DEVELOPMENT REVIEW BOARD  
SUPPLEMENTAL SUBMITTAL

PROJECT NO. 2018-001579

SUBMITTAL DESCRIPTION: Departmental comments indicated a number of items to be addressed in a deferred hearing date, indicated above for multi-family apartments project at 7500 Indian School Rd in the Winrock Town Center. Responses to the comments and revised sheets are provided.

This letter outlines the modifications that have been made to the Apartments at Pennsylvania St and Indian School Rd application for a major site plan amendment to the approved Winrock Town Center Site Development Plan (PR-2018-001579) to address the agency comments that were received.

**SDP1.1**  
 OF

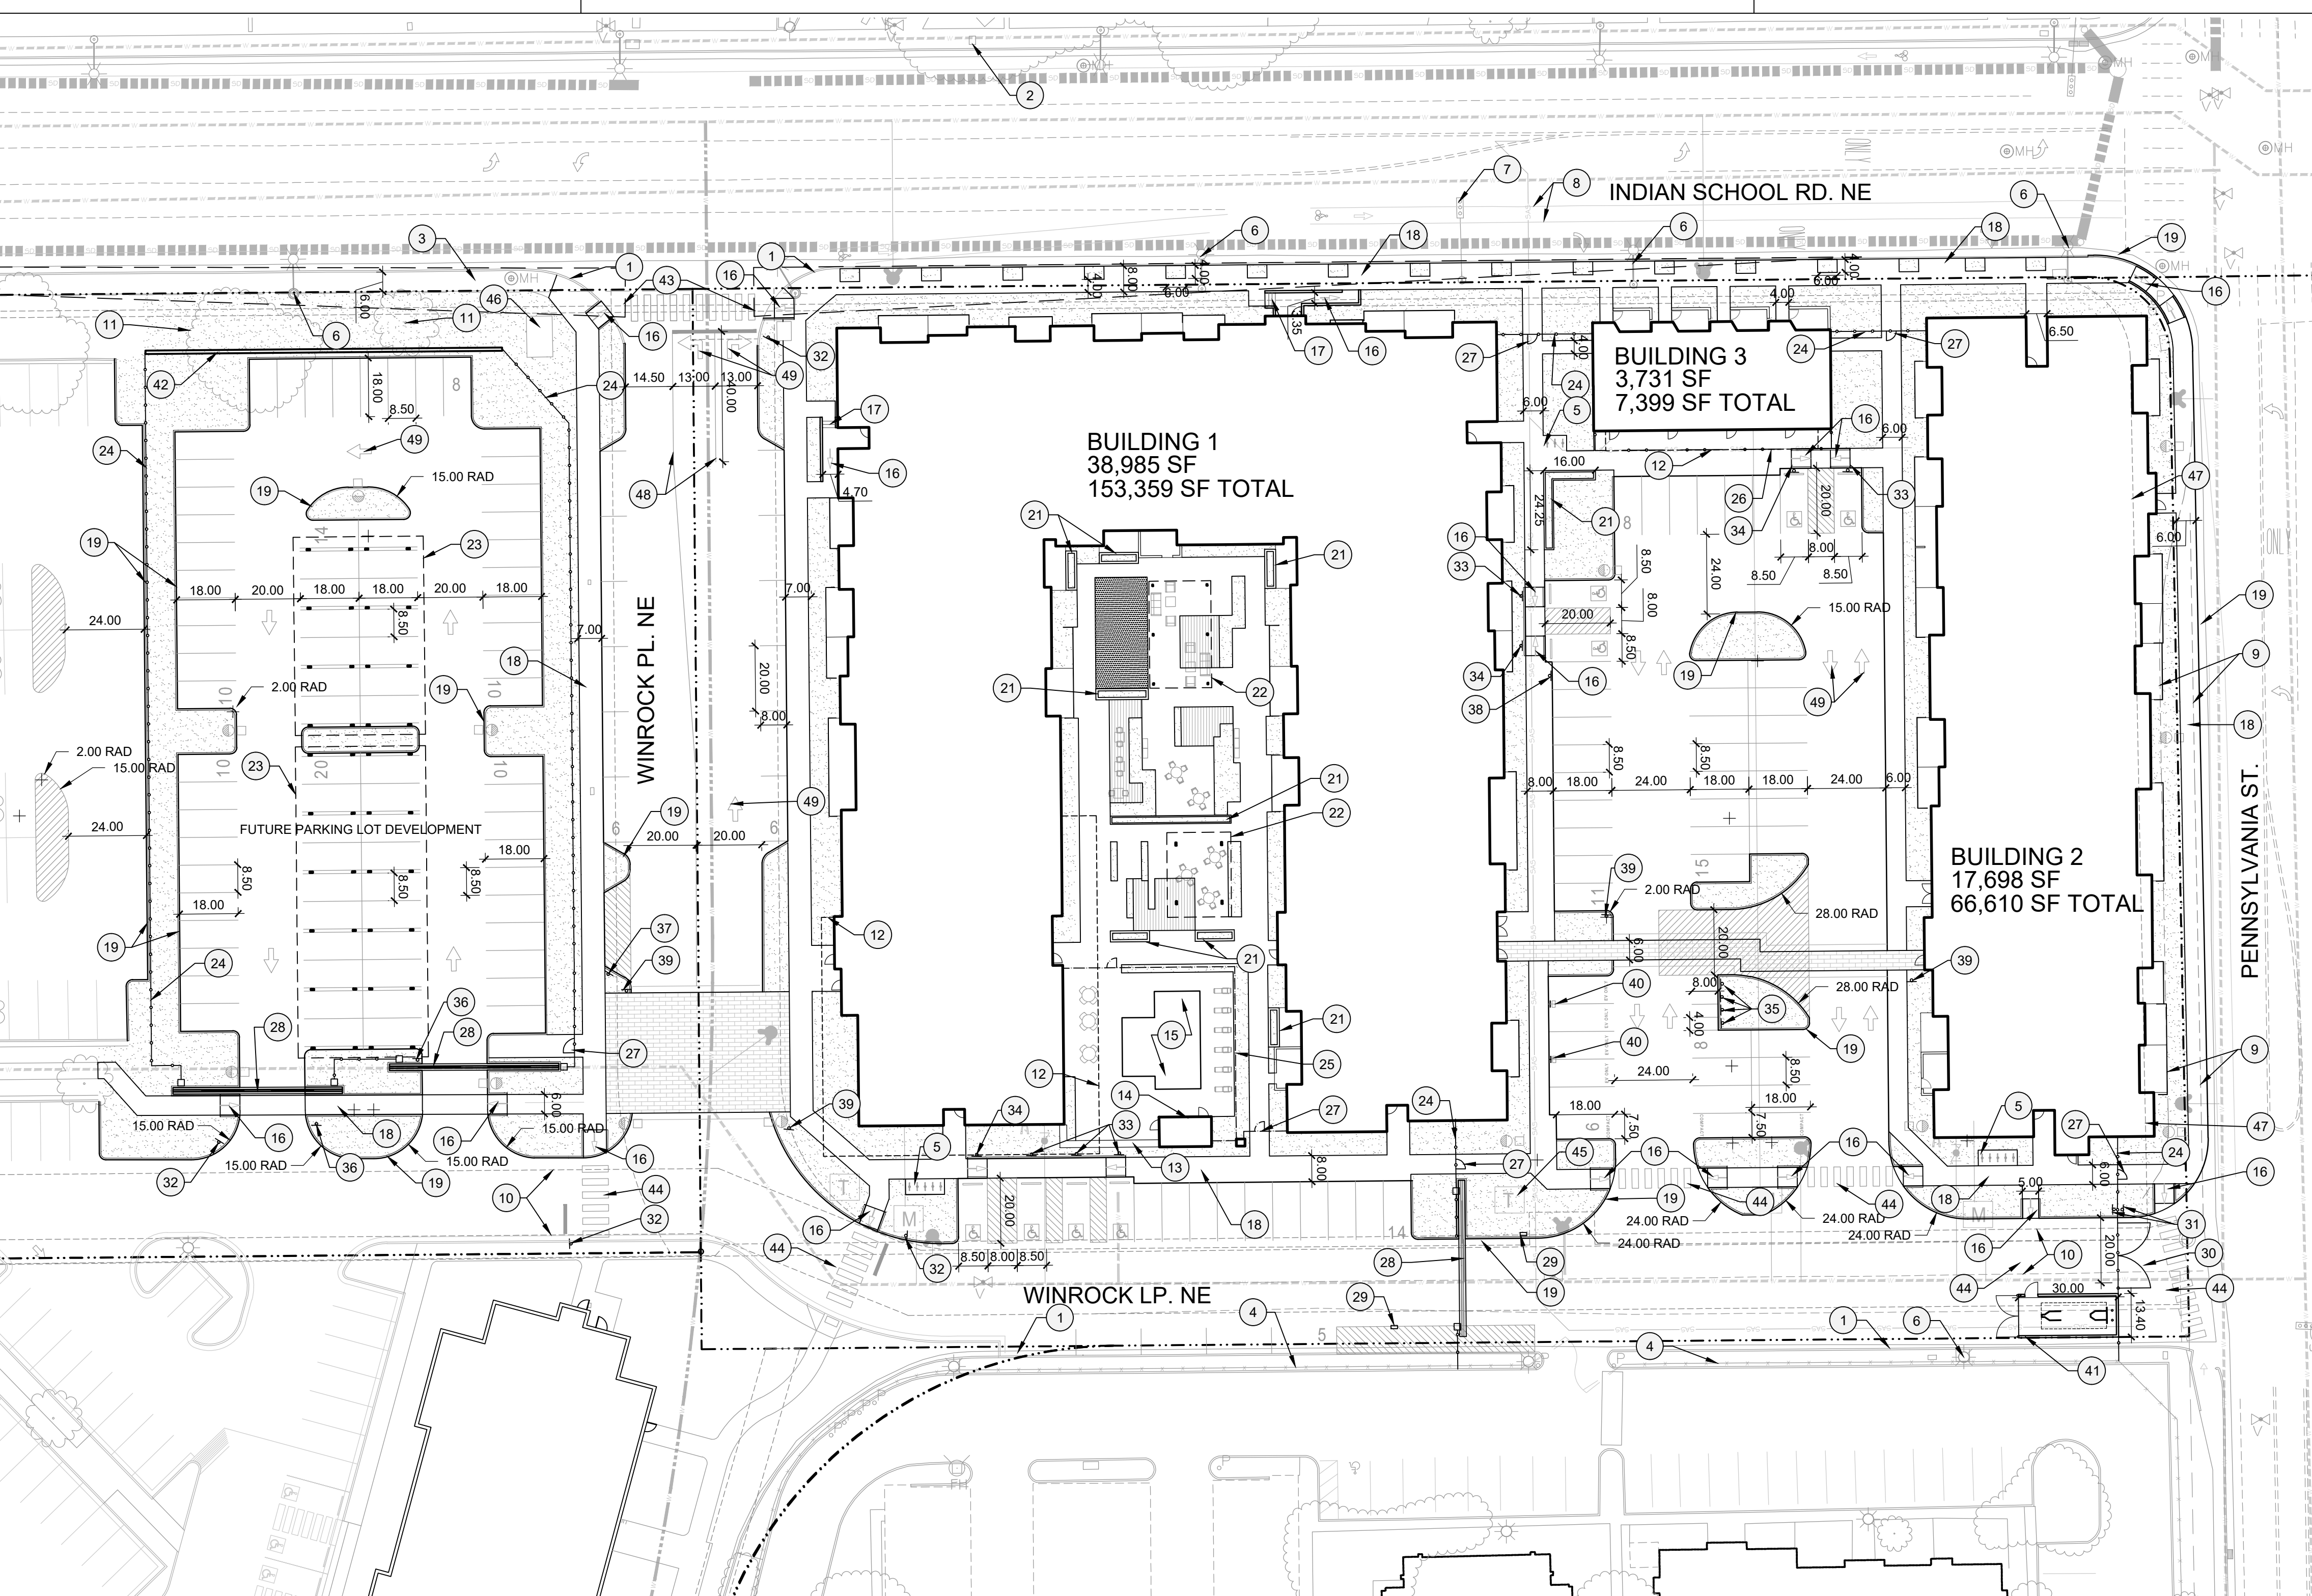
4. Do not place a stop sign for cars to stop on the wide crosswalk.

5. Include “Emergency Access Only” signage on each side of the drive off of Pennsylvania instead of just one side.

6. Include a keyed note for the bike rack location for clarity.

8. A curb ramp appears to be missing at the corner of Indian School and the emergency exit. Call out note for the curb ramp.

*Stop signs have been included per discussions with Jeanne Wolfenbarger.*

*“Emergency Access Only” sign has been added to both sides of gate.*

*Keyed note has been added.*

*Concrete accessible ramp is keyed noted at the north corner of Pennsylvania and emergency access exit. There is an existing accessible ramp at the south corner of Pennsylvania and emergency access exit to remain.*

SDP2.1

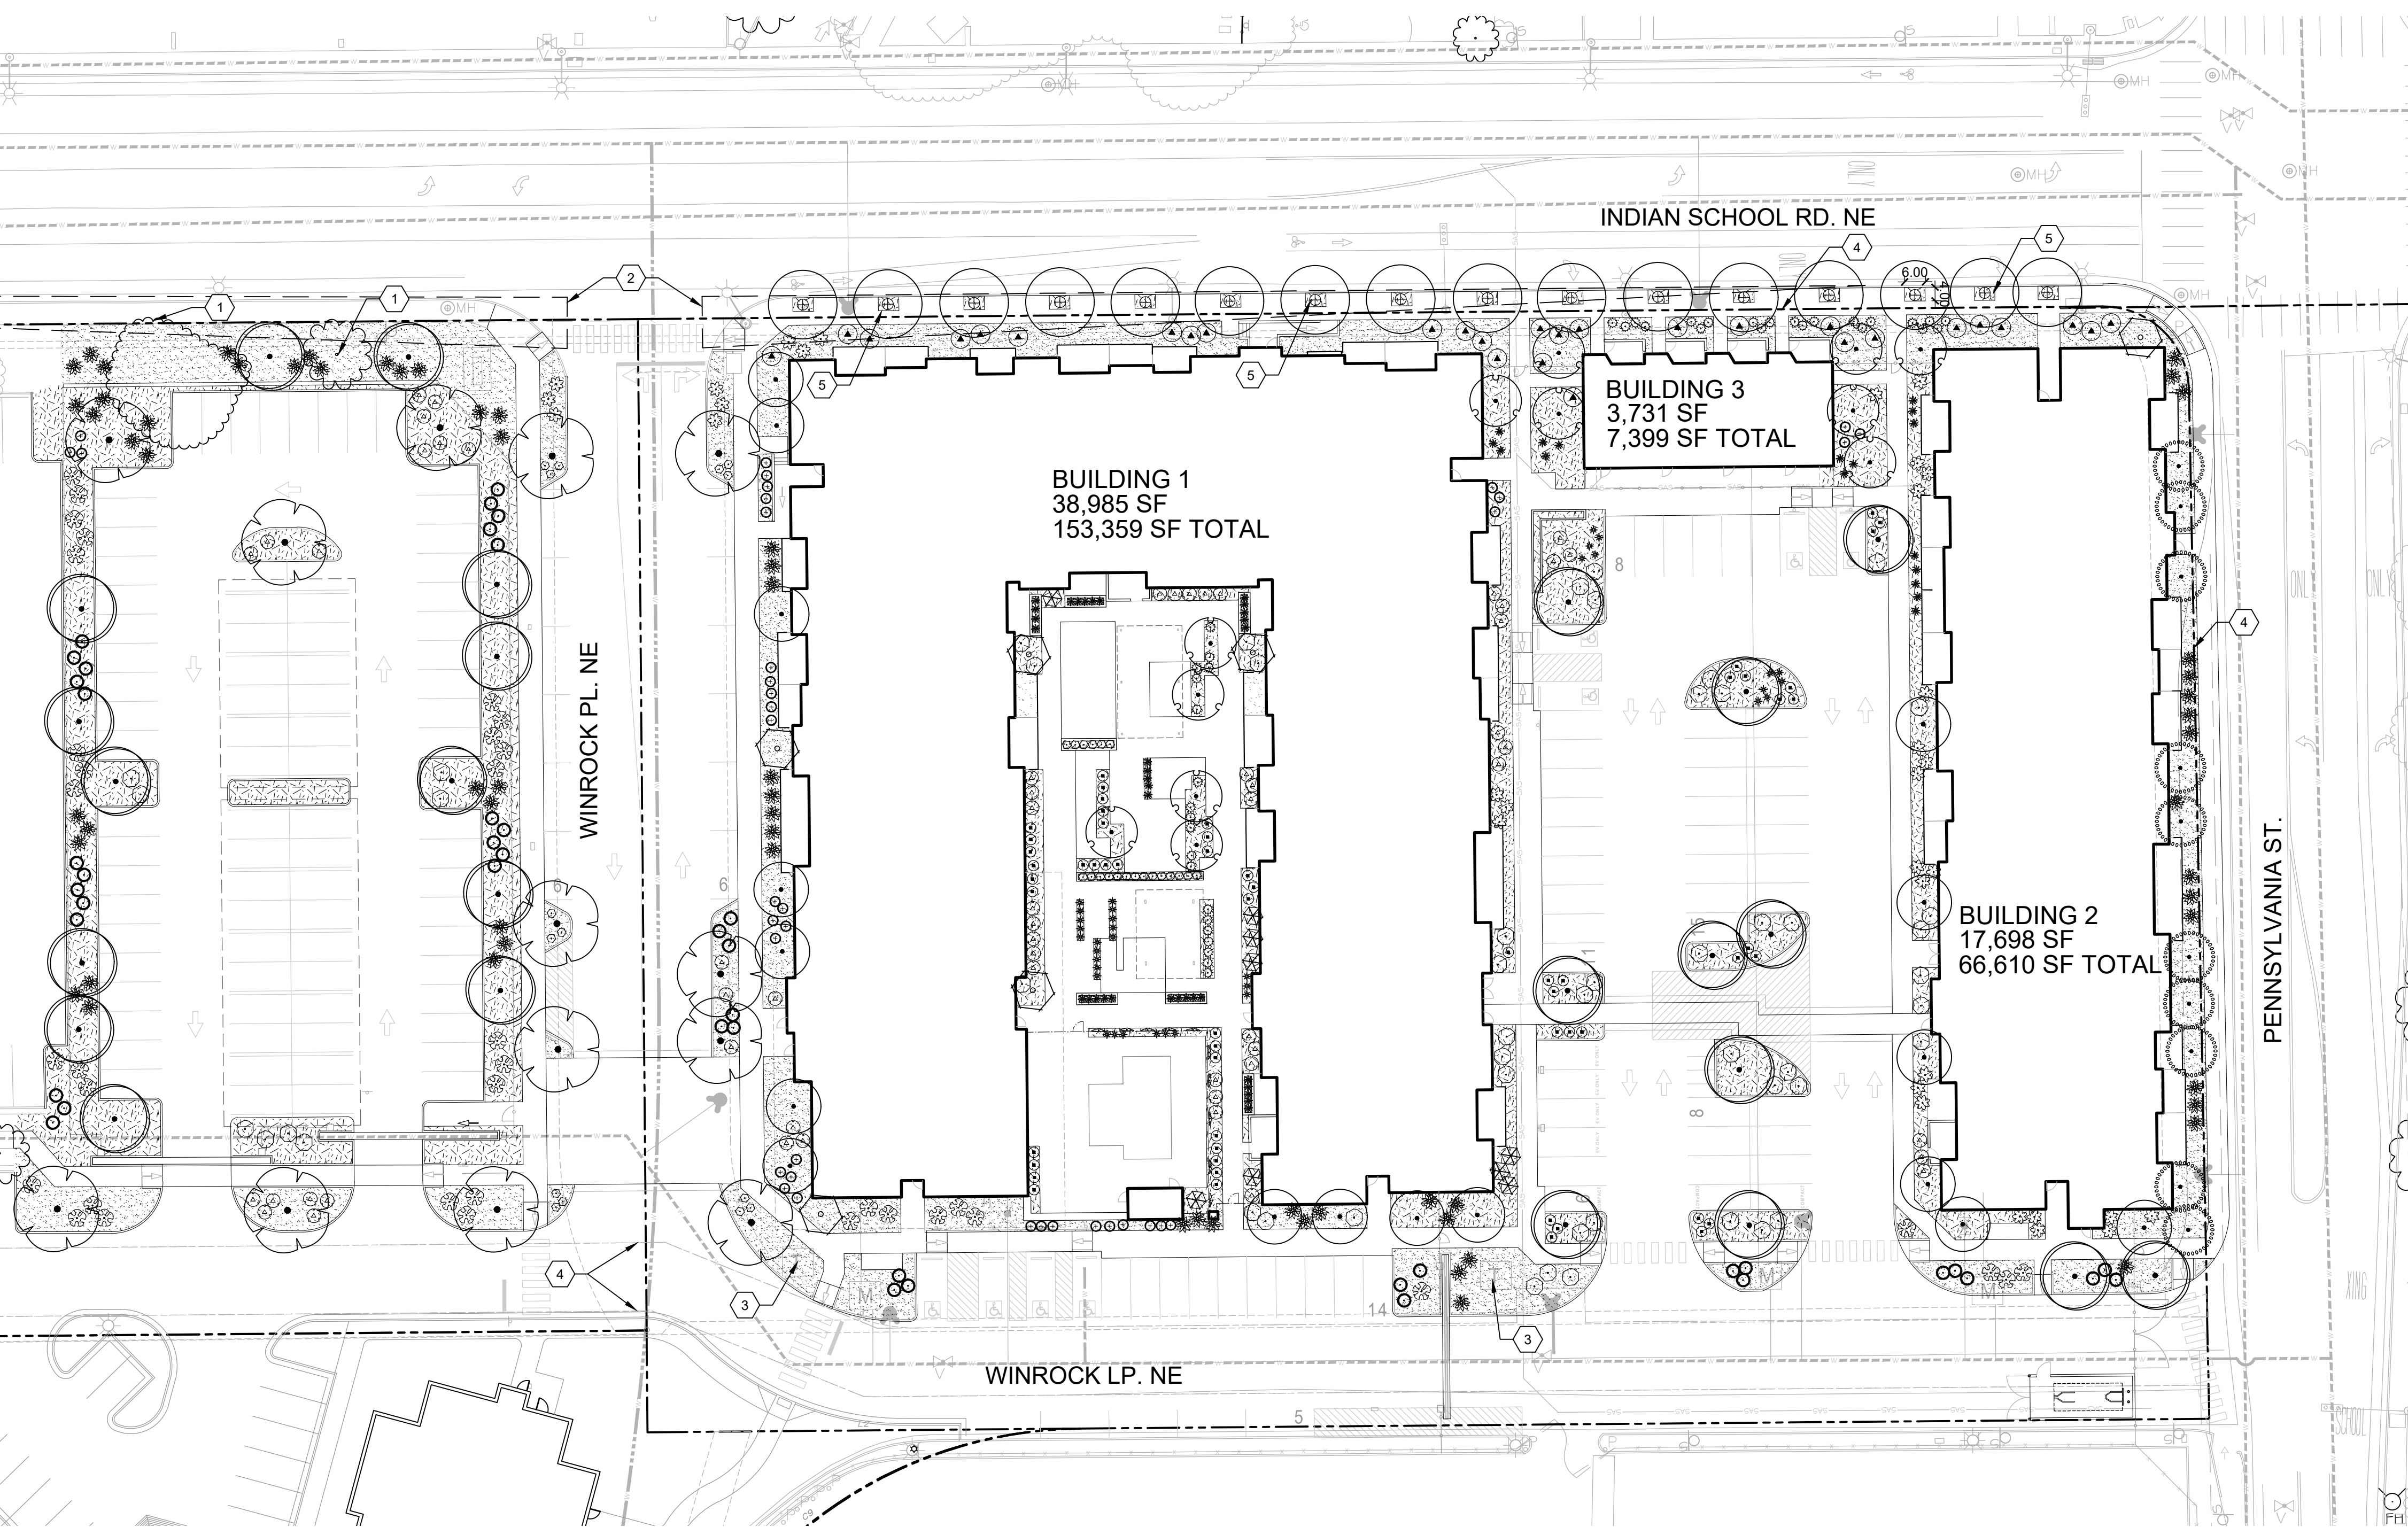
### 1. Confirm that all plant species are on the City's plant list.

*The applicant has revised the landscape plan to ensure that all plant species utilized are on the City's plant list.*
